NASA/TM-2004-213231/Version 0.01
NESC-RP-04-01/03-001-E

Cloud-Aerosol LIDAR and Infrared Pathfinder Satellite Observation (CALIPSO) Spacecraft

Independent Technical Assessment

NASA Engineering and Safety Center Report	Document #: RP-04-01/ 03-001-E	Version: 0.01
Title: CALIPSO Independent Technical Assessment/Inspection (ITA/I) Report			Page #: 1 of 29

Figure 1. Schematic of CALIPSO Propulsion System

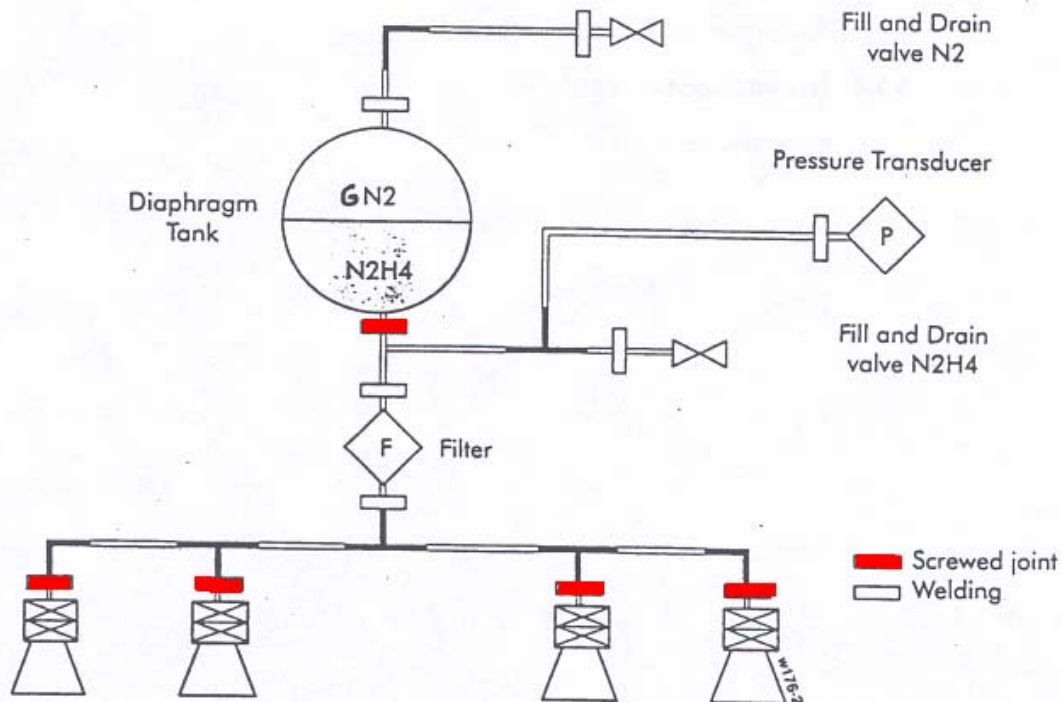
The assessment team observed that there is no isolation valve downstream of the CALIPSO propellant tank. The GRC members were of the opinion that the program needed to address this issue in response to a specific NESC recommendation and offered the following:

“The lack of an isolation valve in the Proteus bus design maximizes the potential for loss if any one of the three hazardous events were to occur, since there would then be no expedient means to stop the flow of hydrazine from the propellant tank. As a result, the worst-case failure effect is that most of the hydrazine in the propulsion system would be released, possibly causing a catastrophic event (personnel injury or fire). There is no evidence that a formal risk assessment was performed to address these three hazardous events related to the design decision to omit an isolation valve.”

“Minority Opinion Recommendation - Program should perform or make available a formal risk assessment to address the three hazardous events related to the design decision to omit an isolation valve. As part of including an isolation valve in the design, this assessment should consider the replacement of the mechanical fitting closest to the tank with a welded joint.”

Figure 2. MS 33656 A/N fitting installation detail

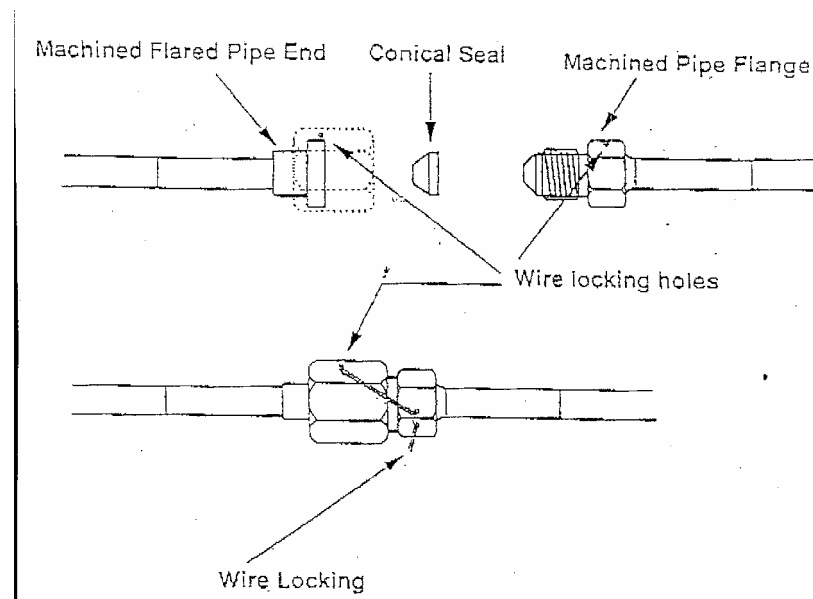
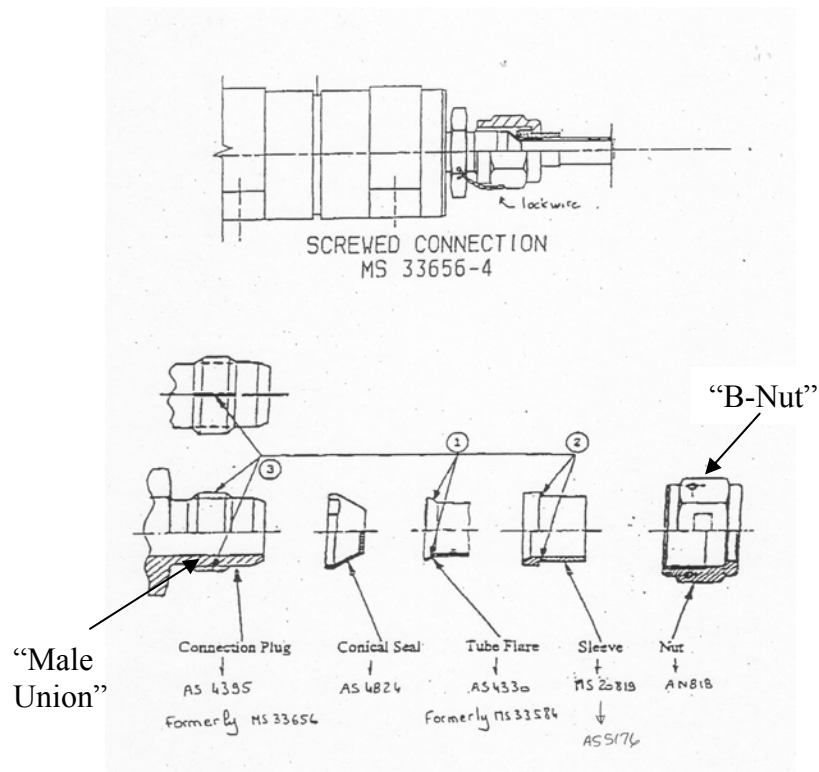
Properly welded fluid connections are inherently more reliable than mechanical fittings and should be incorporated in fluid propulsion system designs when possible. There are some circumstances, however, under which mechanical fittings offer an appropriate design solution. Ready interface to off-the-shelf parts, ease of maintenance, or potential for damage to soft goods during welding all may dictate use of threaded joints. MS-33656 type 37° A/N-fittings have been employed successfully in aerospace applications for many years and are acceptable for limited use providing they are (1) properly assembled, (2) validated by leak check as an assembly before use, (3) exposed only to temperature, pressure, vibration and shock environments for which they are certified, and (4) incorporate a secondary locking feature. The Proteus bus uses five such fittings; one at the hydrazine tank outlet and one at each of the thruster inlets (see Figures 2 and 3 for details). While lock-wire is used as a secondary locking feature, it is suitable only for preventing significant rotation of the B-nut and full disengagement of the fitting. Lock-wire alone will not prevent loss of joint preload⁸ with subsequent reduction of clamping force at the sealing surfaces, and thus cannot be counted upon to prevent a fitting from leaking.

While the NESC was not provided specific qualification and acceptance test data for the CALIPSO Proteus bus, the NESC reviewed relevant test data from other propulsion system and component tests. In general these tests addressed qualification, acceptance and sensitivity of the MS-33656 type 37° A/N fittings for exposure to the environmental conditions of temperature, pressure, vibration, shock and assembly cycles. The following sections of this report summarize three test series conducted on the MS-33656 threaded fitting and the mitigating actions required to assure integrity of the CALIPSO Proteus bus fittings.

NESC-R-001 - Program shall demonstrate that Alcatel training and/or assembly documentation provided for proper lubrication of fluid fittings during assembly. Assembly procedures shall clearly delineate the type, quantity and location where lubricant was applied and ensure sealing surfaces were kept dry and free of any contaminant.

NESC-R-002 – Program shall demonstrate that Alcatel training and/or assembly documentation provided for a visual inspection of fluid fittings prior to assembly. Assembly procedures shall ensure components had no visible defects and sealing surfaces were clean and dry.

Figure 4. Moog Dual Seat Dual Servo Thruster Valve

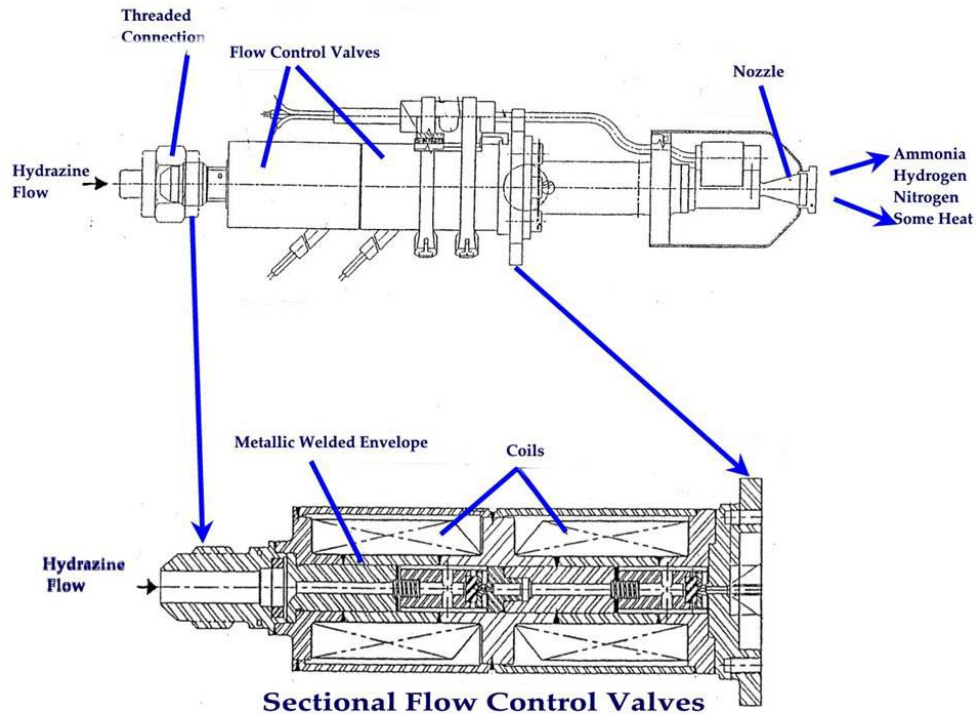
Thrusters selected for the Proteus bus are designed with normally closed series-redundant solenoid-actuated flow control valves manufactured by Moog. The thrusters are of a mature design. A schematic of the valve is depicted in Figure 4.

NESC concludes the potential for external leakage from the thrusters either internally (across the control valves) or externally (thruster casing or seal) poses acceptable risk to personnel providing the program conducts an adequate pre-servicing leak check of each valve. While the program did indicate such testing was planned, NESC was not provided a specific description of the test or its pass/fail criteria.

During a site visit to Aerojet Space Propulsion, an issue with Moog thruster valves similar or identical to the Proteus valves came to light. A manufacturing process change by Moog resulted in a recall investigation on suspect serial number valves²¹. The program was notified of this and was working to clear the CALIPSO Proteus bus valve set.

NESC-R-007 – Program shall demonstrate that pre-servicing thruster leak checks will be adequate to validate system integrity. Leak check procedures shall test each valve independently and shall specify test method, equipment to be used, media, test pressure and allowable leak rate.

NESC-R-008 Program shall verify that the Proteus Moog valves on CALIPSO do not have defective plunger assemblies.

**Figure 5. Thruster Circuit Schematic with New Test/Arm Plugs
(PM refers to spacecraft processor module)**

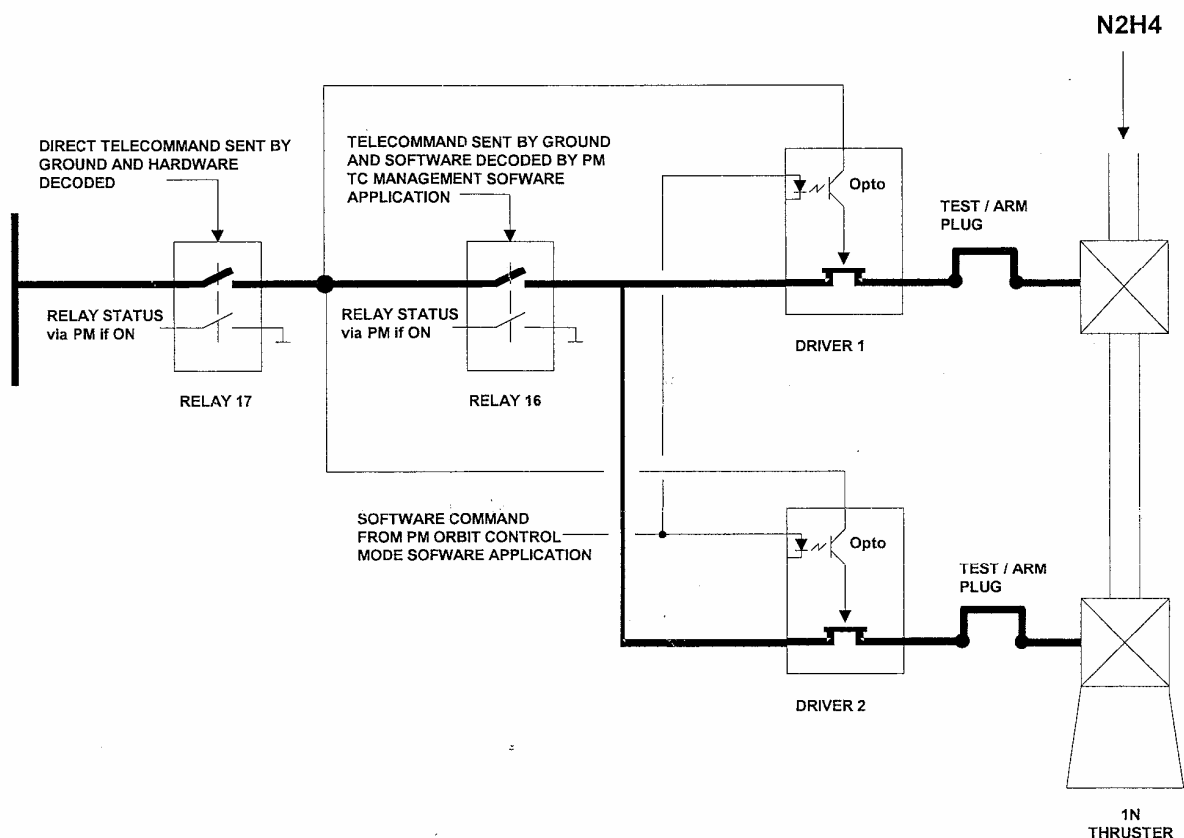
The Proteus thruster firing circuit incorporates a number of controls to ensure valves are not inadvertently opened causing a thruster to fire. NESC concurs the controls are adequate, but recommends further steps be taken to positively preclude the possibility of an inadvertent command during periods of dynamic testing, especially power-up. A schematic of the thruster wiring circuit is shown in Figure 5. It is worth noting that the Astrium specification sheet for the thruster lists nominal flow rate at 0.44 grams per second. Even with all four (4) thrusters firing at nominal flow rate, it would take 4.7 hours to drain the 30 kilograms of hydrazine in the propellant tank.

NESC-R-009 – Program shall demonstrate that test procedures verify relays 16 and 17 are open before power is applied to the spacecraft. Since the design incorporates latching relays, verification of the last stable state by data retrieval or written record is acceptable.

NESC-R-010 – Steps for inserting and removing test/arm plugs shall be explicitly called out in the ground processing timeline. Final installation for flight shall occur as late as possible; until that time, plugs shall only be installed as required for thruster valve testing.

NESC-R-011 – Program shall verify that all thruster firing circuit inhibits function as designed.
